## Product Change Notification / RMES-24GUAK186

CCB 6294 Final Notice: Qualification of MMT as an additional assembly site for selected MCP14A090xx, MCP14A120xx, MCP14A015xx, MCP14A060xx, MCP14A045xx and MCP14A03xx device families available in 8L TDFN (2x3x0.8mm) package.

**PCN #: RMES-24GUAK186**

# Pre and Post Change – Lead frame comparison

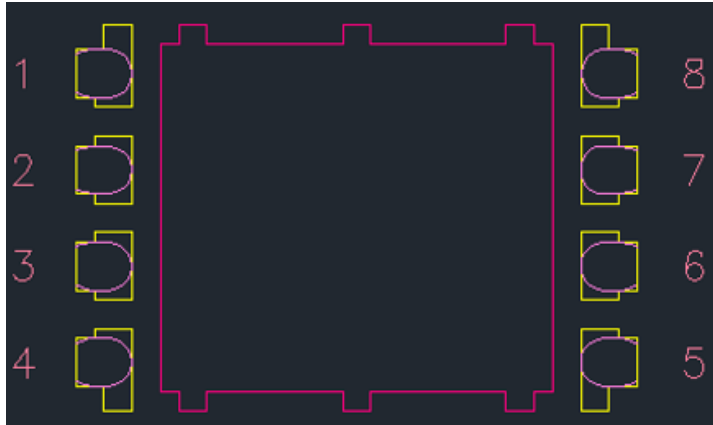
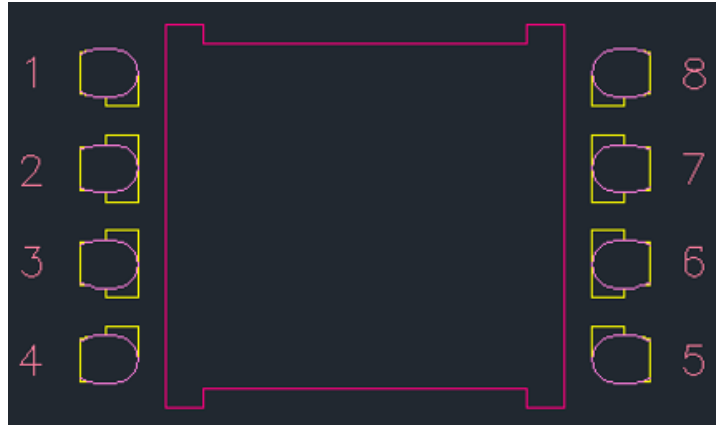
NSEB (UTL-1) / UTL-3	MMT								
Lead Frame comparison	<div></div> <table><tr><td>Leadframe material</td><td>C194</td></tr><tr><td>Lead-lock Design (Locking Hole, Half Etched, Dimple, etc.)</td><td>Yes</td></tr></table>	Leadframe material	C194	Lead-lock Design (Locking Hole, Half Etched, Dimple, etc.)	Yes	<div></div> <table><tr><td>Leadframe material</td><td>A194*</td></tr><tr><td>Lead-lock Design (Locking Hole, Half Etched, Dimple, etc.)</td><td>No</td></tr></table>	Leadframe material	A194*	Lead-lock Design (Locking Hole, Half Etched, Dimple, etc.)	No
Leadframe material	C194									
Lead-lock Design (Locking Hole, Half Etched, Dimple, etc.)	Yes									
Leadframe material	A194*									
Lead-lock Design (Locking Hole, Half Etched, Dimple, etc.)	No

Note: \* C194, A194 or CDA194 Lead frame material are the same, it is just a MCHP internal labelling difference.
